Reviewed By WW Dept

Reviewed By PW

Reviewed By CED 12/10/2021 3:07:50 PM By mschmitz

A Proposed Body Shop Addition and Remodel for MainStreet of Lansing

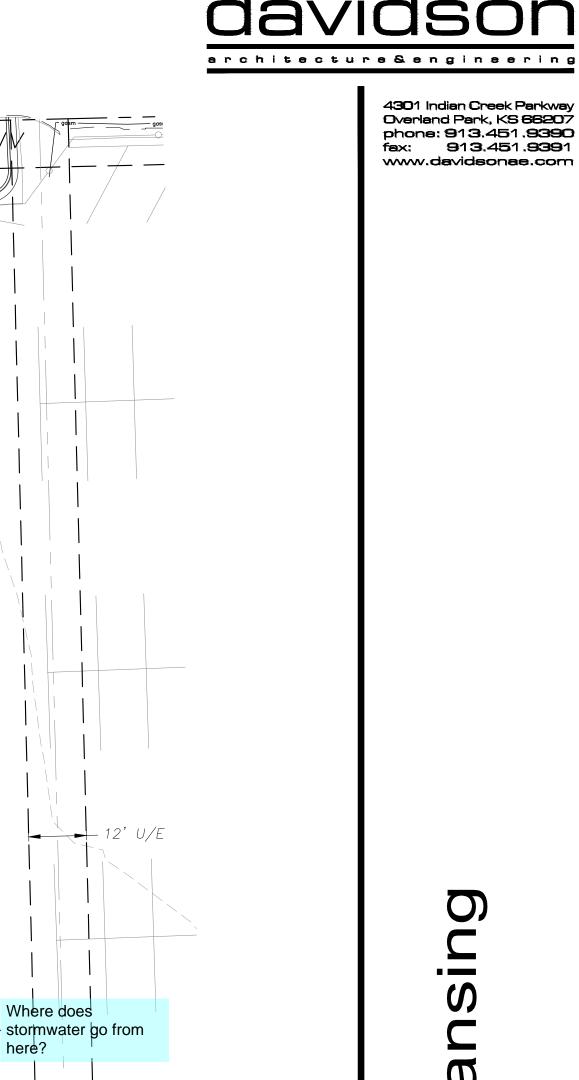
- used? 3. Does the plumbing code require any pretreatment
- facilities for wastewater/washwater from the painting prep, sanding, or paint cleaning processes?

1. I do not see the current or proposed on site or future

sanitary sewer improvements. 2. Will an existing connection to the sanitary sewer be

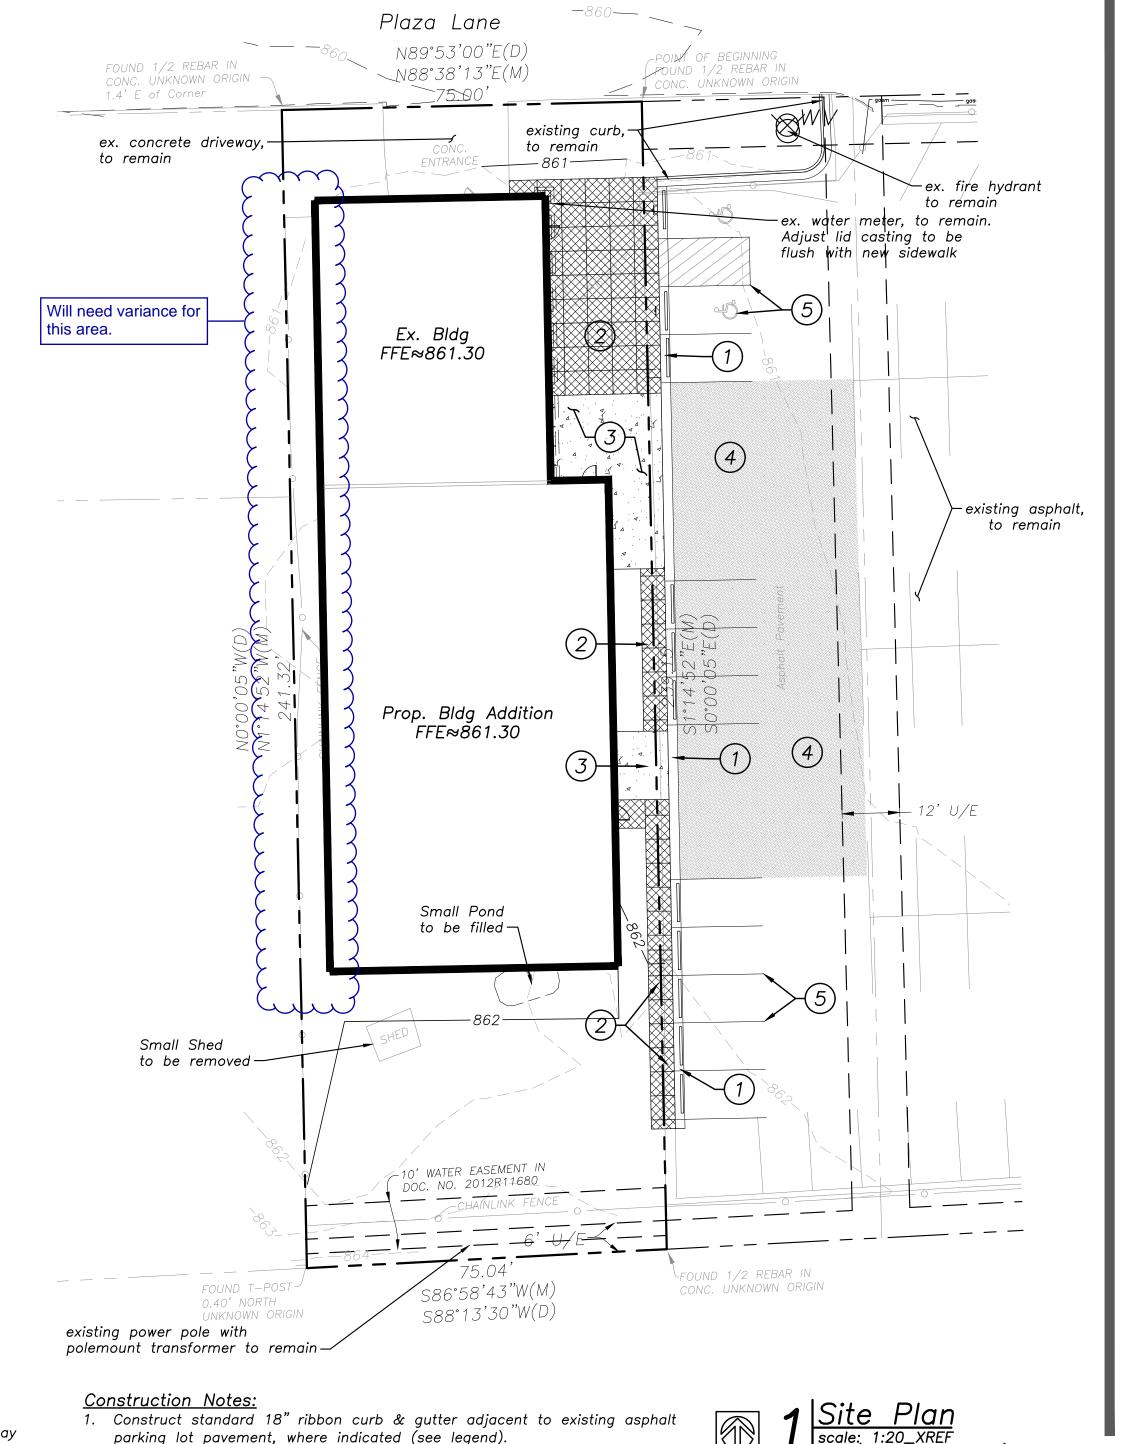
Where does

Will need stormwater calculations / stormwater plan

Will need current vs. proposed water flows from site

Lansing Tech Spec Stormwater Design Criteria apply

Is the plan to sheet flow water onto Plaza Lane to the

is there a designated plan across the asphalt parking

impervious area increase on the 'whole site' vs. this small section. The addition of 7,800 s.f. across the

Will want this information in a report for the file, that clearly demonstrates that no additional flows will be

to increase in impervious area over 5,000 s.f.

& Report. This would indicated that 7,855 s.f. of

impervious area is being added.

due to increase in impervious area.

north? (Plaza Lane is private drive)

lot for the southern water going east?

It might be better to show that the amount of

entire parking lot is less of an impact, especially since the stormwater is planned to flow across the building
